Louisville and Jefferson County Metropolitan Sewer District
700 West Liberty Street
Louisville Kentucky 40203-1911
502-540-6000
www.msdlouky.org

Subject: Interim Sanitary Sewer Discharge Plan
Resubmittal
DOJ Case No. 90-5-1-1-08254

Interim Sanitary Sewer Discharge Plan (ISSDP)

**Figure 7-
Carson Way and Ribble Rd Proposed Improvement Alternatives**

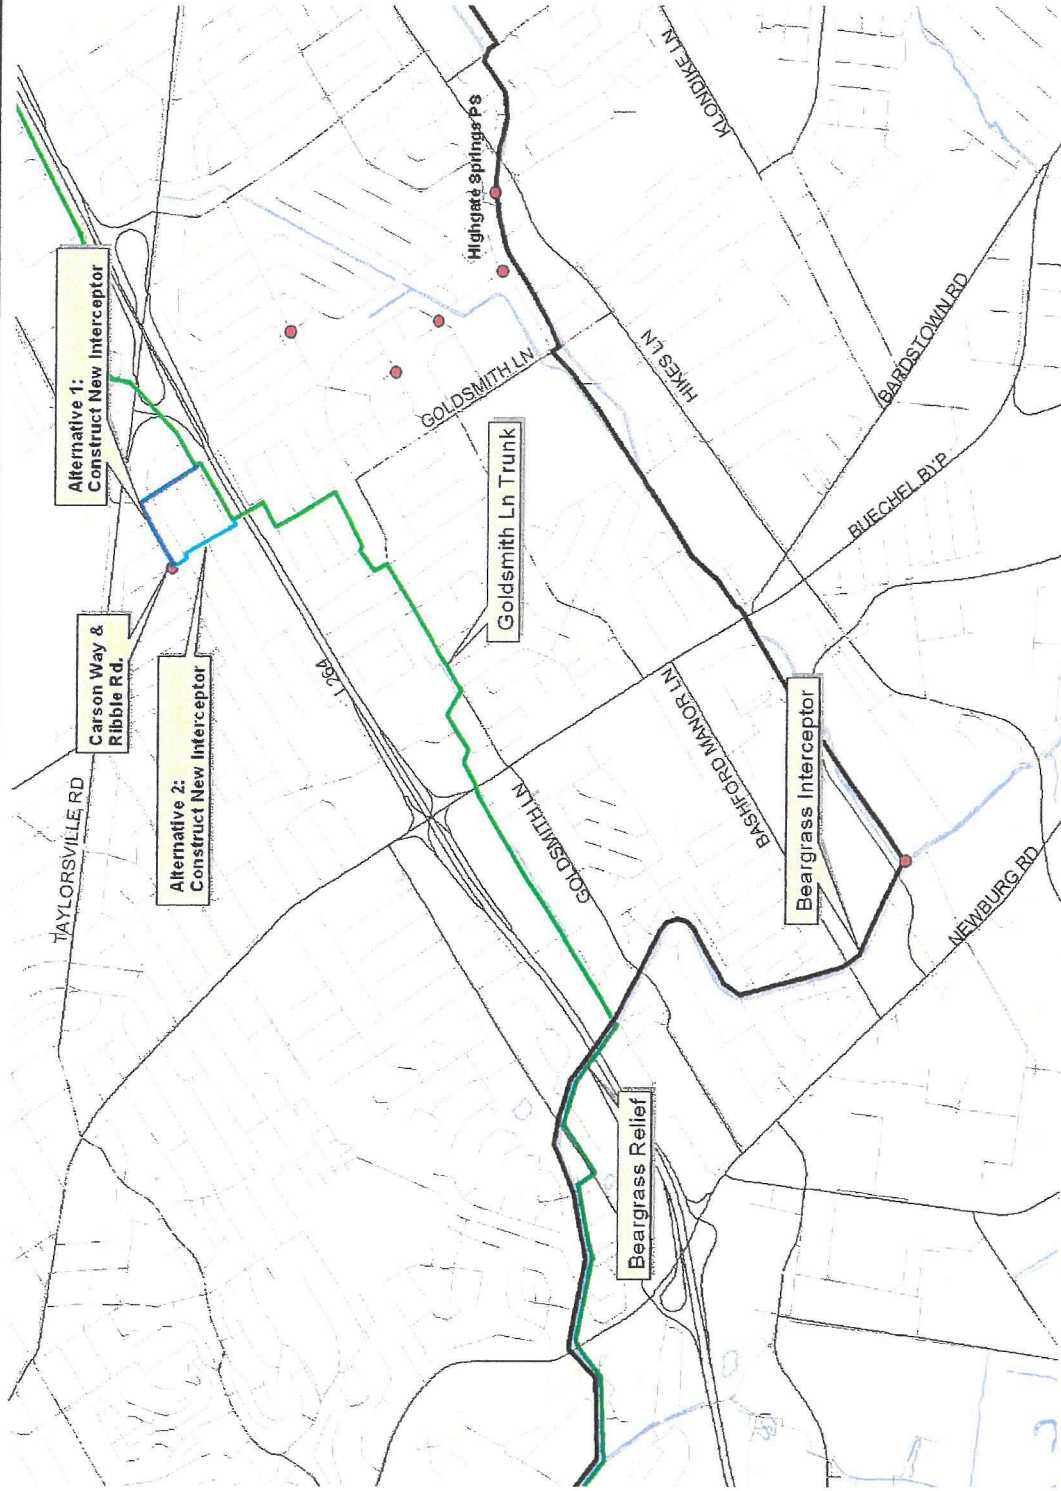
Comment 8 requested a solution schematic for the SSO problem in the Carson Way and Ribble Road neighborhood, similar to Figure 3 in Section 1.

Response 8: Figure 7 has been added to Section 2, illustrating the Carson Way and Ribble Road project.

**FIGURE 9-
ALTERNATIVE 1 – HIGH RATE SECONDARY TREATMENT
PROCESS FLOW DIAGRAM**

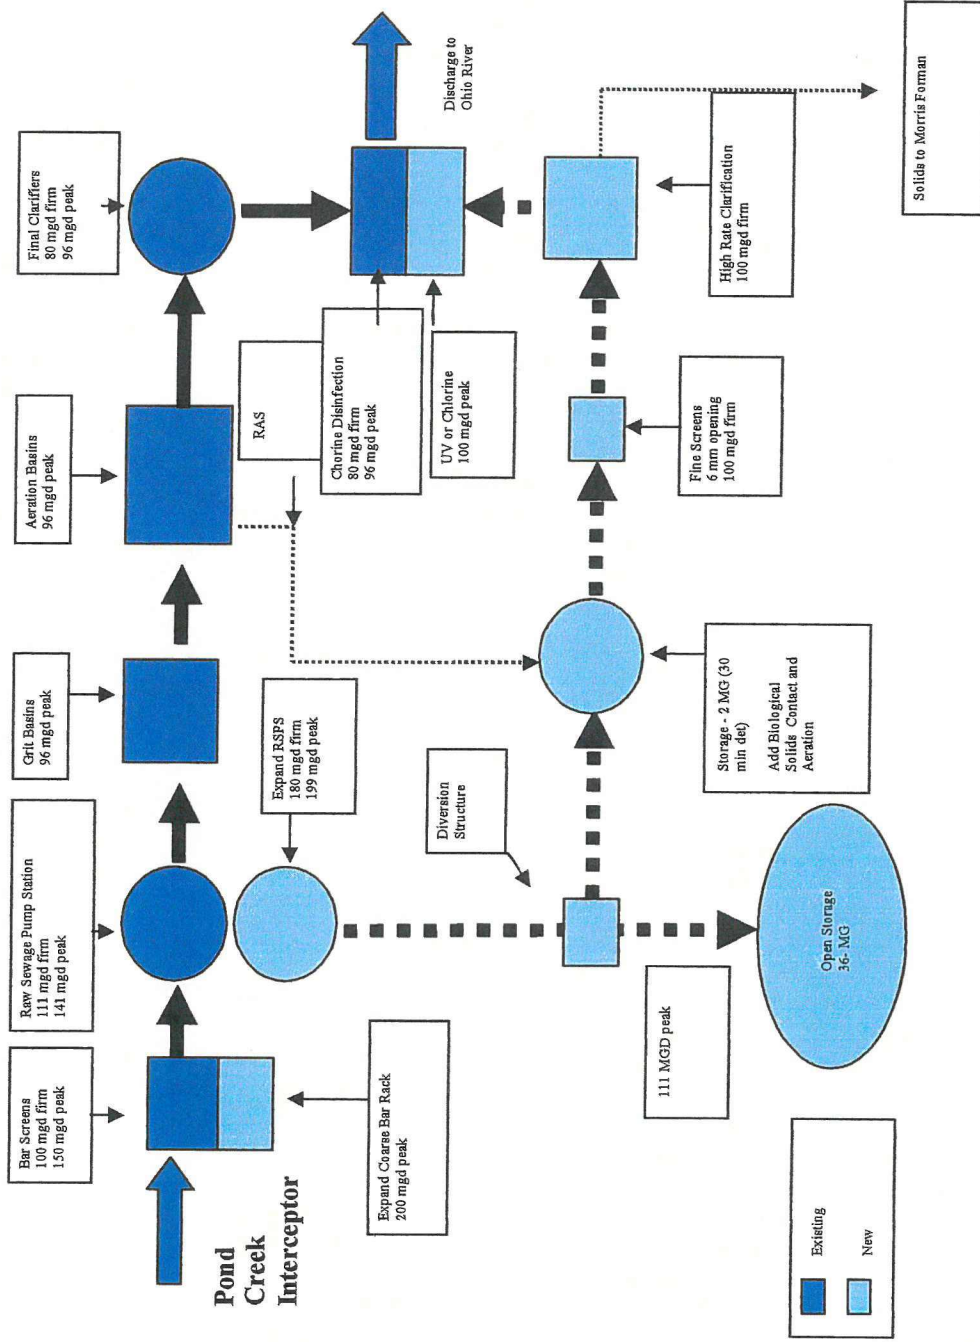
Comment 2 addressed the definition of secondary treatment as it relates to wet weather sidestream treatment.

Response 2: After clarifying discussions with EPA and KDEP technical staff, Section 2.5 has been modified. This section now reflects MSD's commitment to provide wet weather treatment that fully meets the definition of secondary treatment, including the requirement for an 85% monthly average removal of BOD5 and TSS, calculated based on the actual days of operation during wet weather. Process modeling has been initiated to confirm unit process sizing and removal efficiency of the original 2 treatment alternatives. In addition, a third alternative has been added that represents an expansion of current secondary treatment processes, and this Alternative 3 is also being modeled at this time. Results of process modeling for all three alternatives will be submitted to KDEP and EPA as part of the Preliminary Engineering Report scheduled for completion in August, 2008. Preliminary modeling results confirm that proper sizing of Alternatives 1 and 3 will result in facilities that are able to meet all the performance parameters that define secondary treatment. Modeling of Alternative 2 has not been completed, but we are less certain of that Alternative's ability to meet all the requirements as we now understand them. If Alternative 2 cannot be proven to achieve the

performance required, it will be eliminated from further consideration. Figures 9 through 11 are schematic flow charts illustrating the processes currently being evaluated.
